Date: 02/02/2024  
ERA Ref: EA/00032/22

**Planning Ref.:** PA/06860/21  
**Description Proposal:** Storm water relief tunnel to relieve flooding problems near Mater-  
Dei Hospital roundabout.  
**Location:** Site at, Triq Sir Anthony Mamo, San Gwann; Triq Sir Anthony  
Mamo, Birkirkara, Triq Dun Karm, Msida

**Figure 2:** map showing the area that contribute to runoff in wied għolliieqa during operation phase (Source: AA Report, December 2023).

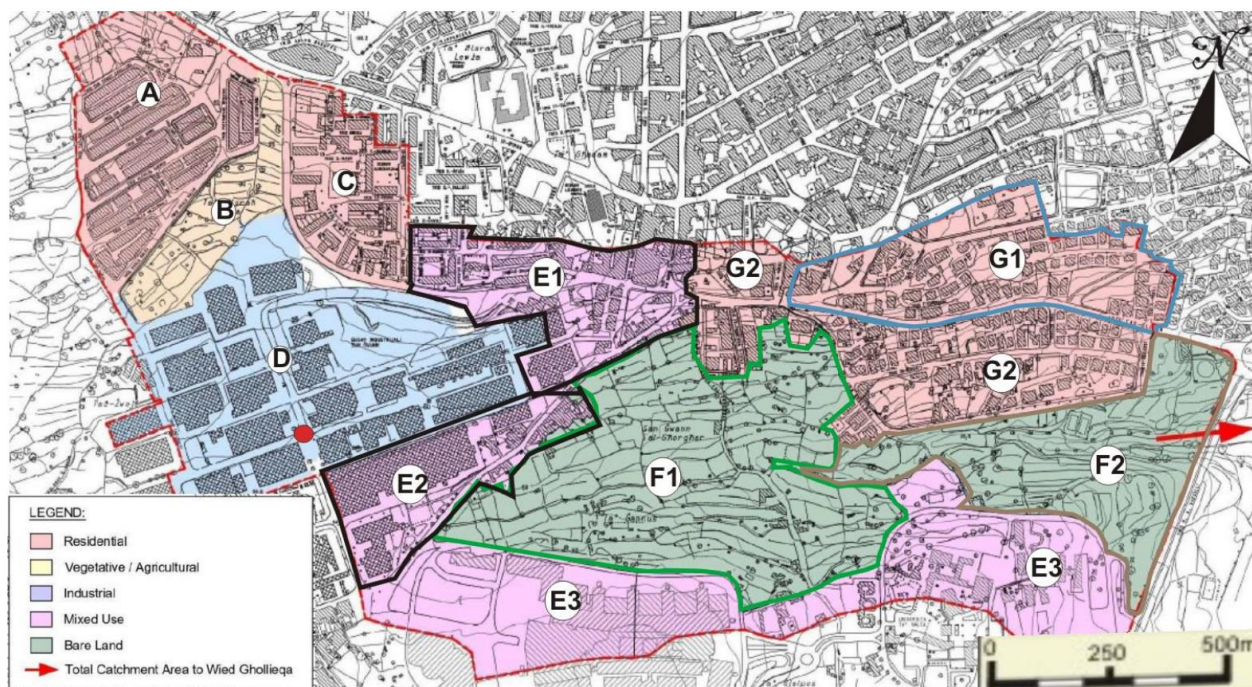
The reduction of runoff discharge may impact the western part of the valley, which is primarily agricultural in nature. Due to the reduced surface water runoff, it is expected that fluctuations in the microclimate of the valley take place, leading to a decrease in intensity and time for

plant transpiration. The AA also outlines that the runoff passing through the valley is less likely to be polluted in view that the runoff to be diverted from the project passes through the San Ġwann Industrial Area, which is likely to be polluted. It is to be noted that the western area of the valley is still supplied with significant runoff discharge from surrounding catchment areas (labelled as 'Area B' in figure 1 above). With regards to the central and eastern areas of the valley system, these consist of the most ecologically sensitive areas of Wied Ġħollieqa. These areas are also supplied by alternative watercourses that are situated along the perimeter of the valley, noting that these areas are located at a considerable distance from the San Ġwann Enterprise Hub – Industrial Area. The aforementioned areas which supply the central and eastern parts of the valley include E1, E3, G2, F1 and F2 as illustrated in figure 2 and table 1, above.

The reduction of runoff water volumes towards Wied Ġħollieqa from the west of the valley is acknowledged, however deemed to be not significant on the valley's ecological systems.

The AA recommends monitoring to verify that the predicted absence of significant effect on the ecologically sensitive areas of Wied Ġħollieqa or observe any long term effects that may occur throughout operation phase.
